Subject: ELECTRIC PARKING BRAKE (EPB) WARNING LIGHT ON / EPB WILL NOT RELEASE IN COLD WEATHER	Bulletin No: 04-002/15
	Last Issued: 07/14/2015

2016 CX-5 vehicles with VINs lower than JM3KE*****676325 (produced before June 9, 2015)

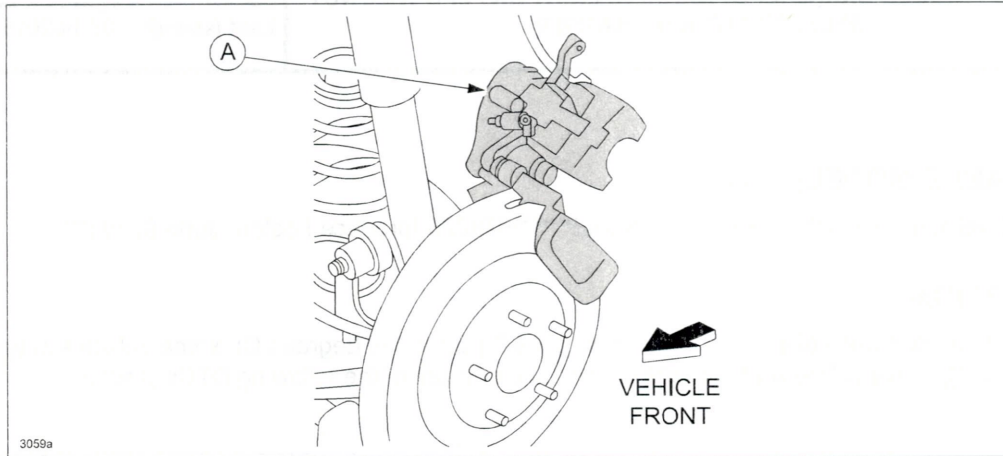
This concern may be caused by the EPB motor gear unit (A) dimensions being out of specification. The machining dimensions of EPB motor gear unit have been improved to eliminate this concern.

1. Verify the customer concern.
 - If DTCs C2005:19 (RH) and/or C2006:19 (LH) are present, proceed to Step 2.
 - If DTCs C2005:19 (RH) and/or C2006:19 (LH) are not present, this bulletin is NOT applicable. Proceed with normal troubleshooting procedures according to MS3 online or the workshop manual.
2. Replace the Electric Parking Brake Motor Gear Unit and Rear Brake Caliper(s) according to the instructions on MS3 online or the Workshop Manual (section 04-12 ELECTRIC PARKING BRAKE MOTOR GEAR UNIT REMOVAL/INSTALLATION and (section 04-11 CALIPER (REAR) DISASSEMBLY/ASSEMBLY).
3. Verify the repair.
